HARTING Product Change Notification

PCN/17/028/C+N

Title: Crimping Tool Han C 4 - 10 mm² - External

09 99 000 0377

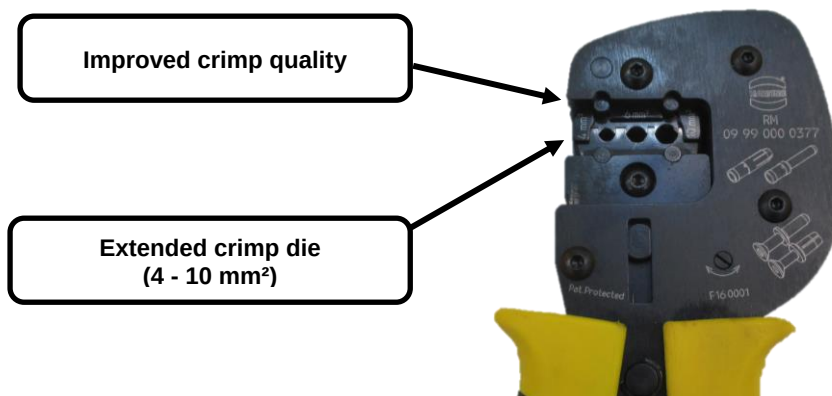
We are glad to inform you that an updated Crimping Tool for Han[®] C 4 - 10 mm² will be available soon. Due to the updated crimp die the crimping quality will be improved. Furthermore, the field of application is extended to process Han[®] C 4/6/10 mm² contacts.

09 99 000 0377 rev.: 01
